TRANS/WP.29/GRRF/52
29 November 2002

Working Party on Brakes and Running Gear (GRRF)

REPORT OF THE WORKING PARTY ON BRAKES AND RUNNING GEAR (GRRF)
ON ITS FIFTY-SECOND SESSION

ARRANGEMENT OF TYRE MARKINGS

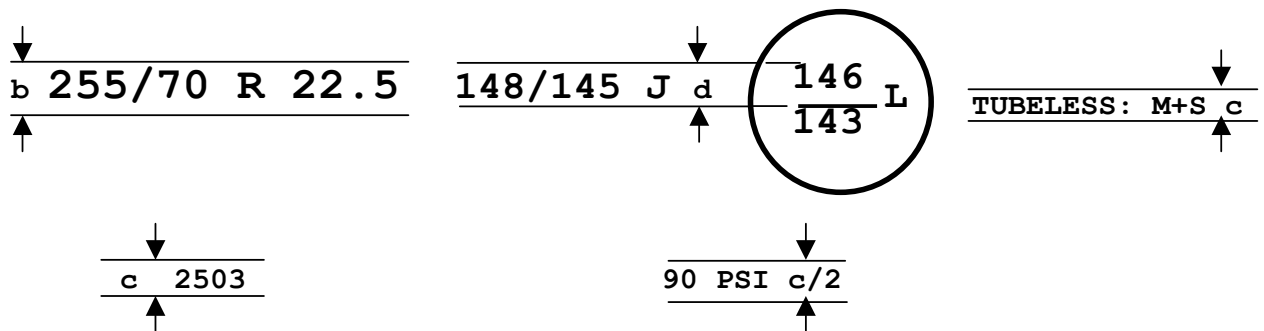
Annex 3, amend to read:

MINIMUM HEIGHTS OF MARKINGS (mm)	
	Tyres of nominal rim diameter < 508mm (Code 20) or of nominal section width ≤ 235mm (Code 9)	Tyres of nominal rim diameter ≥ 508mm (Code 20) or of nominal section width > 235mm (Code 9)
b	6	9
c	4	
d	6

These markings, given as an example, define a pneumatic tyre:
